# Access Compliance Report

## Public Rights-of-Way

### (Curb Ramps)

Intersection ID: 23277	Main Street: S_TRYON_ST	Cross Street: CAROWINDS_BV	Location: E
ADA ID: C53011D98C18	Ramp Type: Perp	Initial Pass/Fail: Fail	Overall Compliance: No
Severity Score: 22.5			
Codes/Mitigation Info/Possible Solution		Field Measurements/Component Compliance

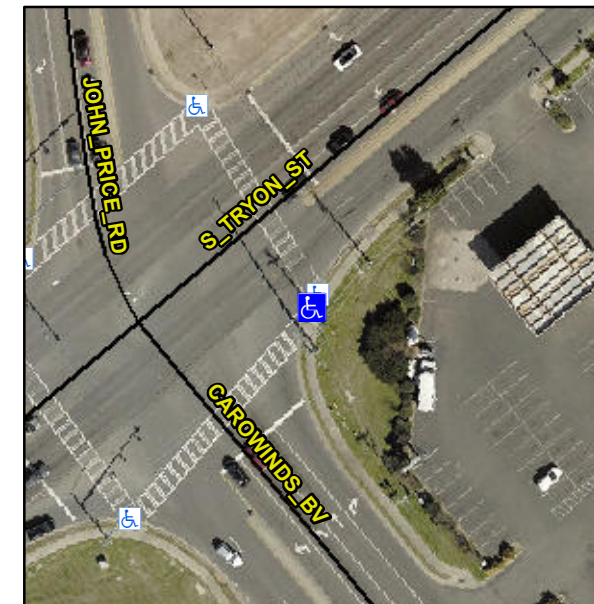
**R304.5.1, R304.2.2, R304.5.3**

Compliance	Description	Data	Compliance	Description	Data
N/A	Ramp Length (in)	54.0	No	Ramp Slope (%)	8.5
No	Ramp Width (in)	46.0	No	Ramp XSlope (%)	2.1
N/A	Flare Type LT	N/A	N/A	Flare Type RT	N/A
N/A	Flare Slope LT (%)	N/A	N/A	Flare Slope RT (%)	N/A
N/A	Flare Traversable LT?	N/A	N/A	Flare Traversable RT?	N/A
N/A	Landing Length (in)	N/A	N/A	DWS Provided?	N/A
N/A	Landing Width (in)	N/A	N/A	DWS Contrast?	N/A
N/A	Landing Slope (%)	N/A	N/A	DWS Length (in)	N/A
N/A	Landing X Slope (%)	N/A	N/A	DWS Full Width?	N/A
N/A	Landing Curb? (Y/N)	N/A	N/A	DWS Offset (in)	N/A
N/A	Shared Landing?	N/A			
N/A	Gutter Ponding?	N/A	N/A	Gutter Slope (%)	N/A
N/A	Gutter Lip Ht (in)	N/A	N/A	Gutter X Slope (%)	N/A
N/A	Painted X Walk1?	Yes	N/A	Painted X Walk2?	N/A
	X Walk 1 Direction	To SW		X Walk 2 Direction	N/A
N/A	X Walk 1 Width (in)	115.0	N/A	X Walk 2 Width (in)	N/A
	X Walk 1 Slope (%)	0.1		X Walk 2 Slope (%)	N/A
	X Walk 1 X Slope (%)	0.5		X Walk 2 X Slope (%)	N/A

**Remove & Replace Entire Ramp.**
